Re: Docket No. 120058-EQ - Petition for approval of a negotiated renewable energy power purchase contract for power purchased with Rayonier Performance Fibers, LLC, by Florida Public Utilities Company.

Florida Public Utilities Company's Response to Staff's First Data Requests

ATTACHMENT A

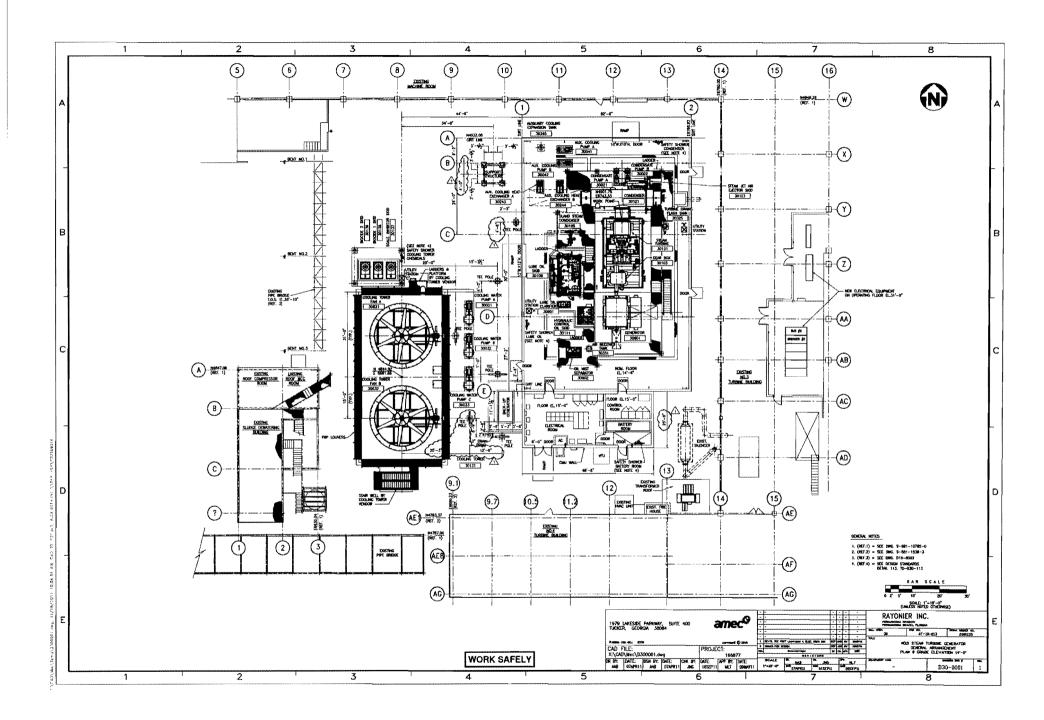
13. Please provide a general layout diagram of the equipment that will be purchased or constructed for the operation of this facility, including structures, boilers, turbines, etc.

Response: Please see Attachment A.
